July 13, 2017

Reference: *Supplemental Site Investigation and Remedial Action Plan Review March 27, 2017 Email, April 28, 2017 Email, and June 14, 2017 email*
Former Wayne Pigment Corp.
300 South Barclay and 139 East Oregon Street
Milwaukee, Wisconsin
FID No. 241029470
BRRTS No. 02-41-553395 and 03-41-547627

KEY ENGINEERING GROUP, LTD.
File No. 1609-0017

FIGURE 6
BUILDING 11 ACTIVE VAPOR MITIGATION SYSTEM DESIGN
WAYNE PIGMENT CORPORATION
300 SOUTH BARCLAY STREET & 139 EAST OREGON STREET
MILWAUKEE, WISCONSIN

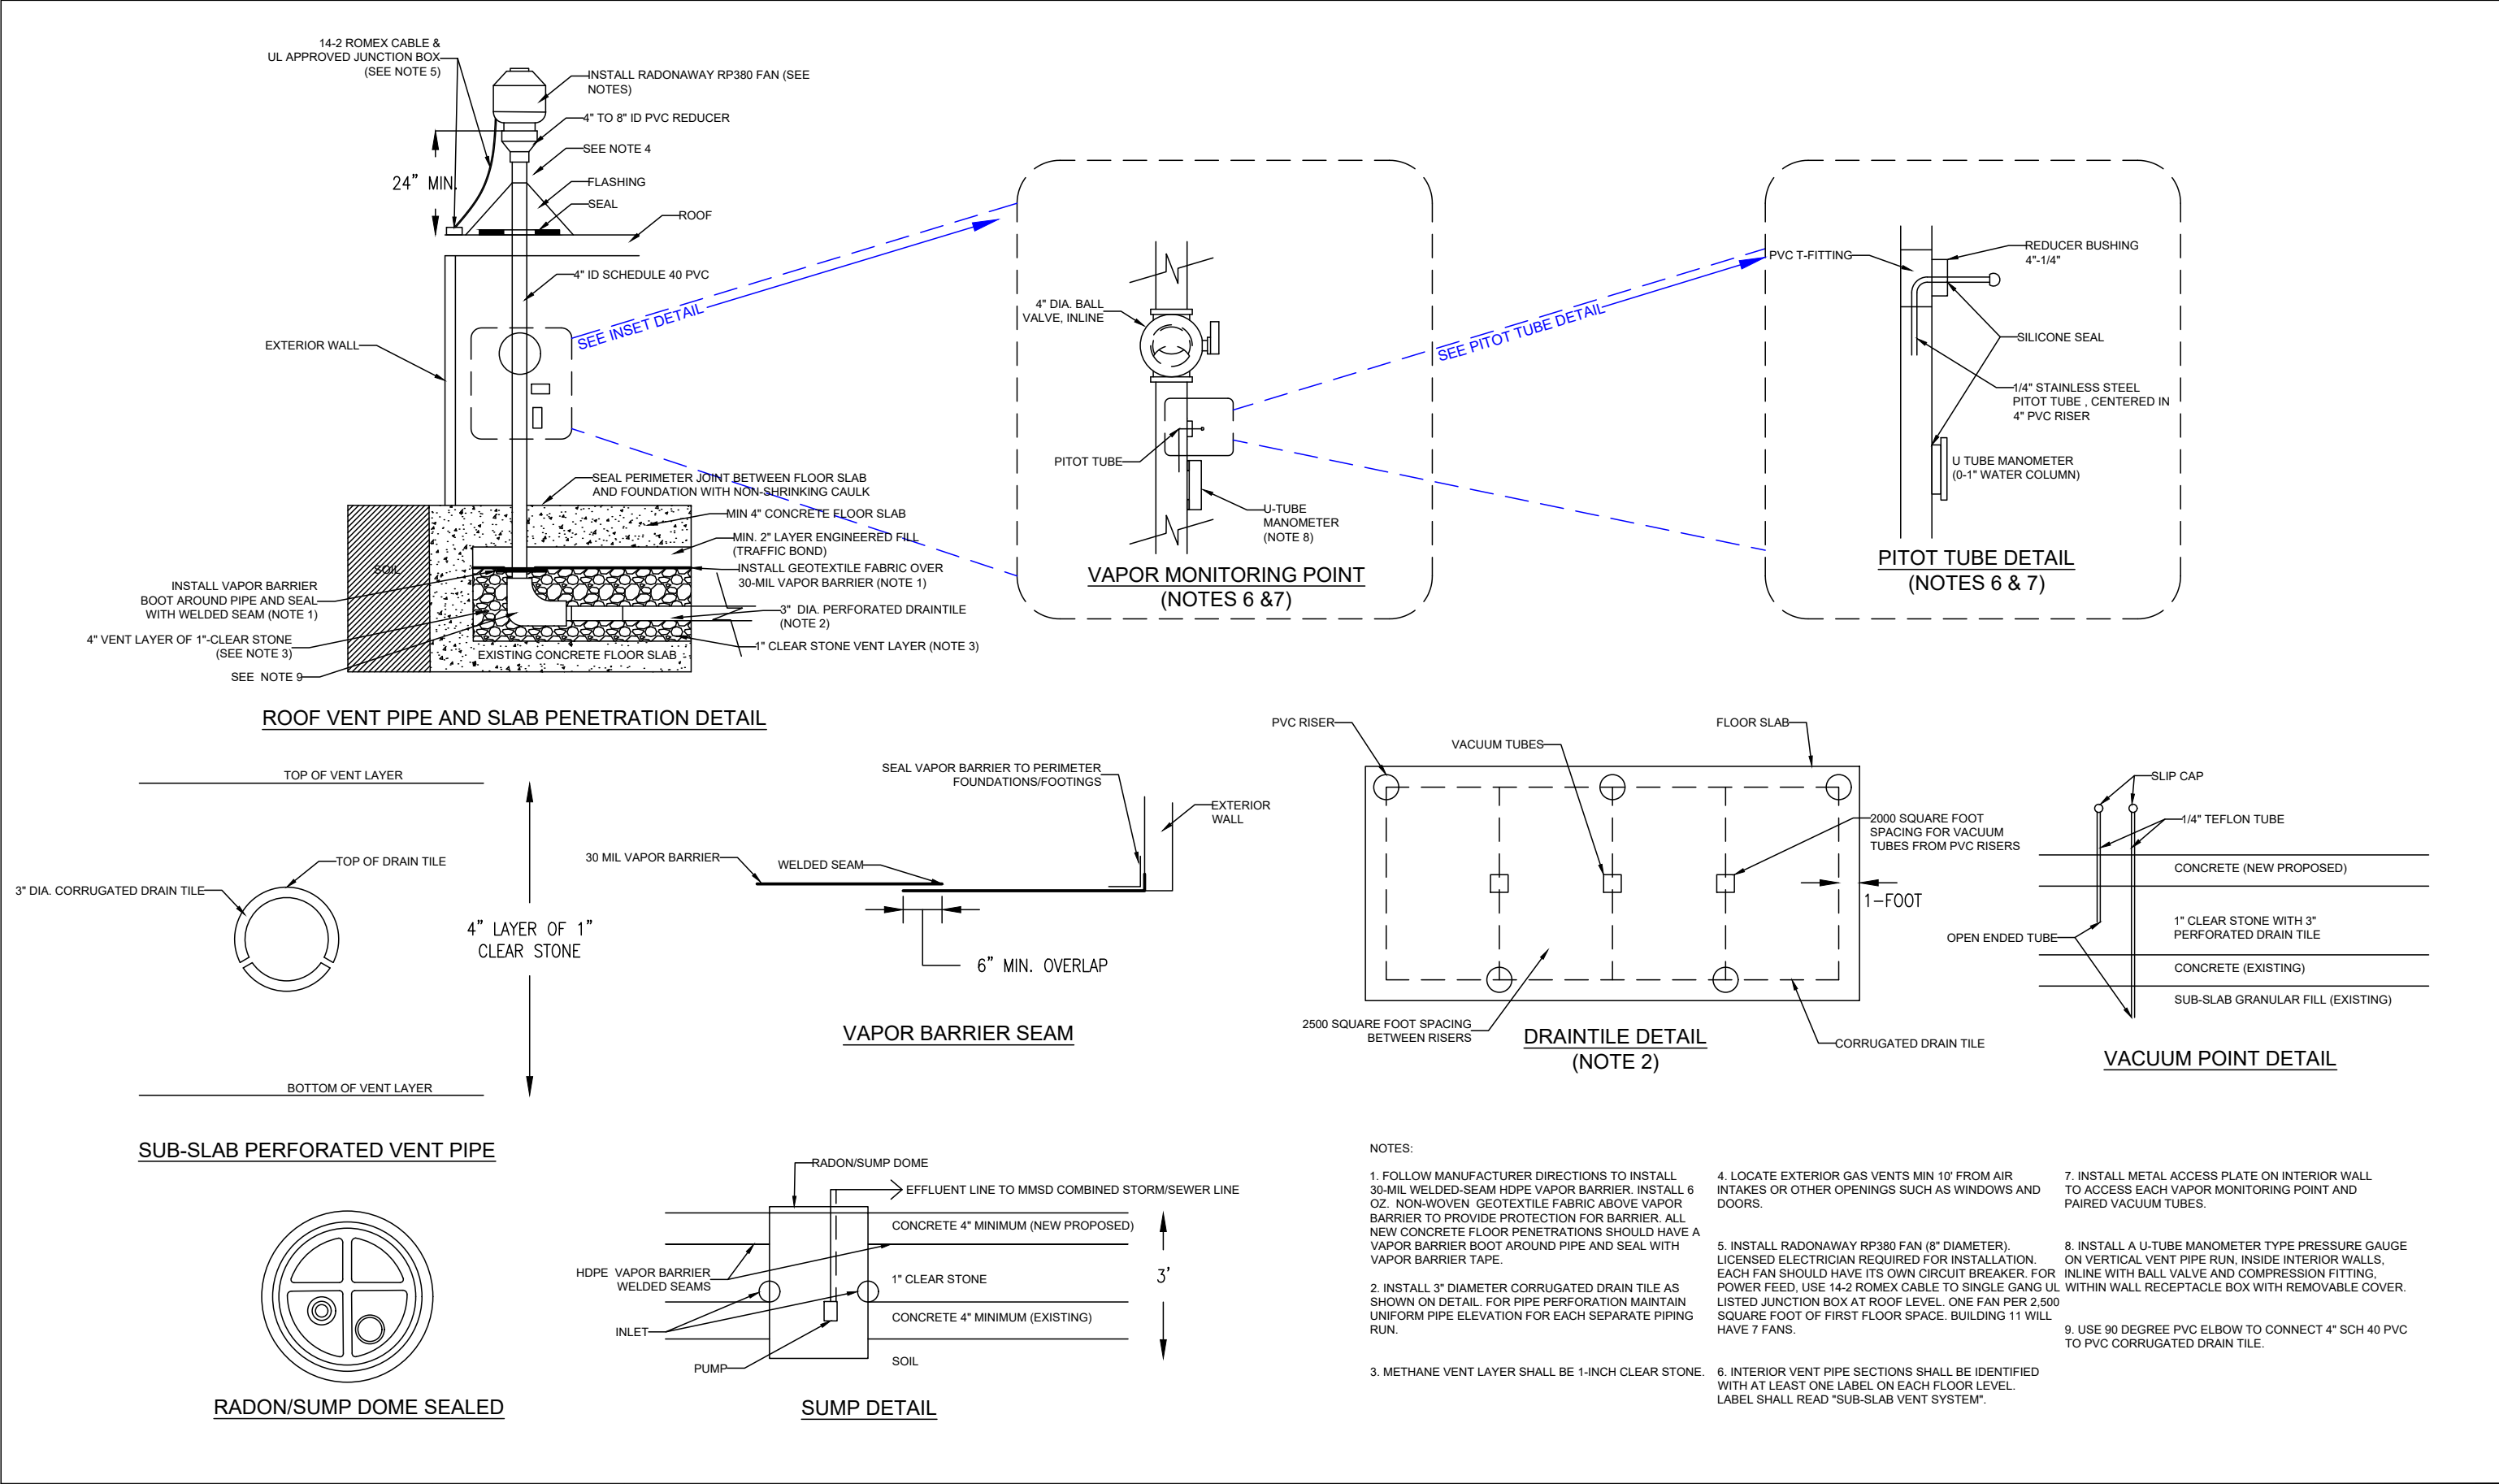
16. *Discussion with Alyssa Sellwood. She suggested the following regarding the active system design: She suggested that the systems in Buildings 33 and 34 be designed with clean air intakes. This would be good for Building 11 too, if possible. (See attached figure) To allow verification of system effectiveness, consider installing ports during construction that extend to below the new floor to allow testing for pressure differential. Also consider installing a port or ports extended below the original floor for future testing for TCE to determine if the system can be turned off. Provide further details on construction design and how you will verify SSDS is operating as designed for the active system(s). Indoor air sampling will be required.*

KEY discussed the proposed sub-slab design in greater detail with Ms. Sellwood of the WDNR. Ms. Sellwood was in agreement with KEY that in order for the proposed design to be effective, the interstitial granular space must exert a negative pressure. To install clean air intakes will negate negative pressure, effectively disabling the system from pulling a vacuum. Ms. Sellwood stated that KEY will have to prove the system is working. KEY informed Ms. Sellwood that we will be installing a sampling tube that will extend from the occupied space to the interstitial space, and a second tube extending from the occupied space to below the original floor slab. The sampling tubes will have a dual purpose:

In addition, KEY discussed with Ms. Sellwood that we will be installing a sealed sump within the interstitial gravel space. The sump pump would remove water that might accumulate within the interstitial space. The sump will be sealed air tight to ensure the negative pressure can be maintained using a radon/dome lid.

Active vapor mitigation systems will be installed under the two proposed building additions between Buildings 33 and 34 and south of Building 11. Active vapor mitigation system design is presented on Figure 10. The active vapor system design was discussed with Ms. Alyssa Sellwood of the WDNR in April 2017. Below is a brief description of the system design:

FIGURE 1
SITE LAYOUT MAP
WAYNE PIGMENT CORPORATION
300 SOUTH BARCLAY STREET
MILWAUKEE, WISCONSIN

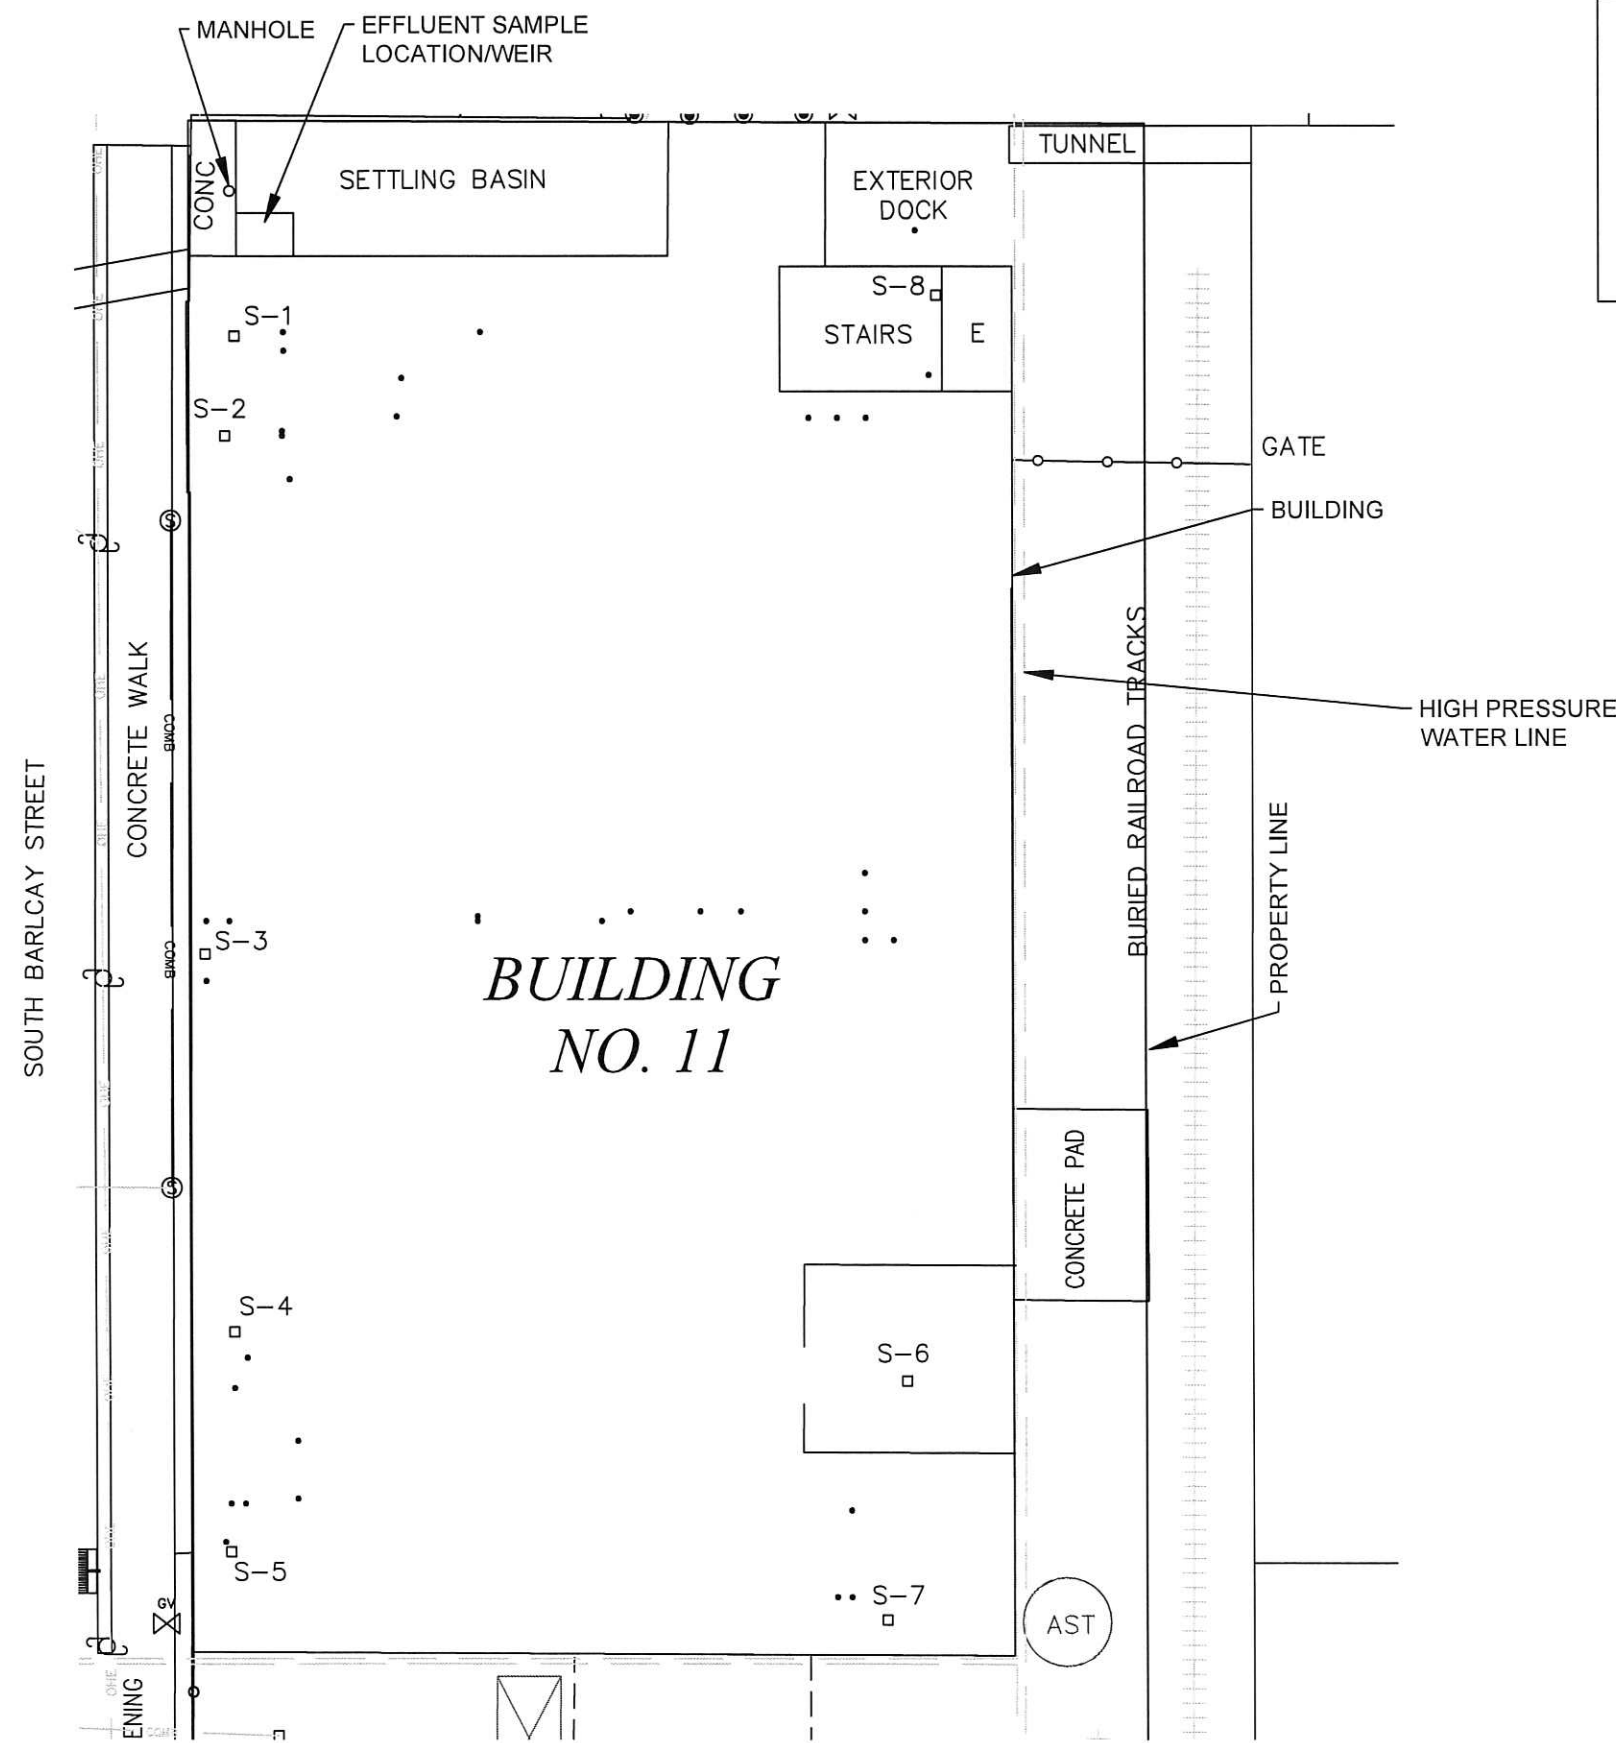
11. Utilities: We have previously requested this and would like additional information about underground utilities below building 11, sanitary connections and construction of sumps, where they discharge and whether they are currently discharging to the sewer. Also provide specific information (including maps) regarding the location and construction of new utility lines and how current lines will be abandoned. Also provide details on construction of new utilities, i.e., will utility collars will be constructed to prevent contaminant migration? Discuss the status of future disposition of sumps in building 11.

- East of MW-12 – Monitoring well MW-12 is only located approximately 17 feet from Building 11. There is a high-pressure water line that runs along east wall of Building 11 (Figure 1). A well cannot be safely installed any closer to the building in this area. Additionally, installing another well this close to an existing well seems unwarranted.

Building 11 utilities were discussed in Section 2.2.1 of the Supplemental SIR/Revised RAP. Building 11 is serviced by municipal sewer and water, as well as natural gas and electric. A site layout map with utilities is presented as Figure 1. The location of sumps is presented on Figure 2.

FIGURE 3
MONITORING WELL MW-4 BENZENE GROUNDWATER TREND GRAPH
 WAYNE PIGMEN CORPORATION
 300 SOUTH BARCLAY STREET
 MILWAUKEE, WISCONSIN

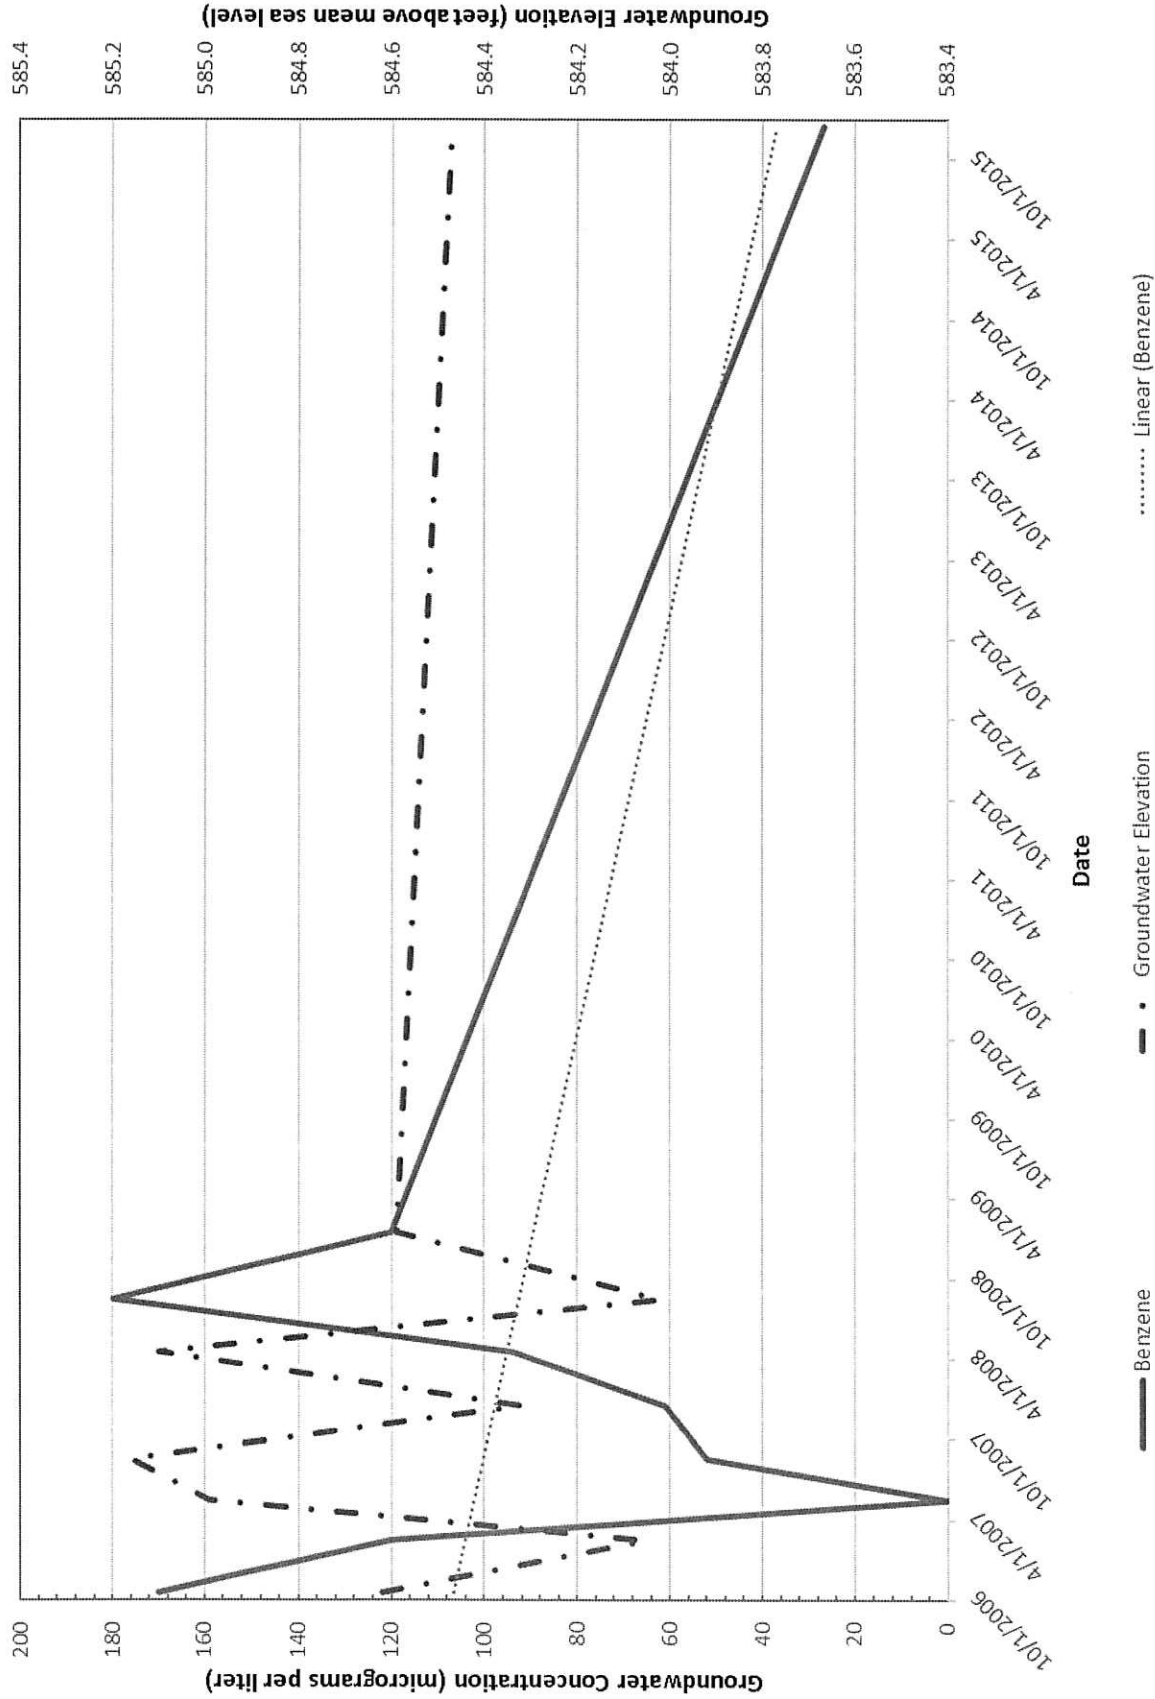
9. *Groundwater: Provide a more thorough discussion of groundwater contamination results including assessment of trends, where contaminants are migrating off-site and if and where remediation is needed. You identify need for remediation of TCE and metals. No discussion of PVOCs or PAHs is provided.*

A trend line graph for benzene in monitoring well MW-4 is presented as Figure 3. Benzene concentrations continue to decrease over time. Total trimethylbenzenes and total xylene concentrations exceeded their respective ESs in December 2015 for the first time. These concentrations will be monitored long term to evaluate trends.
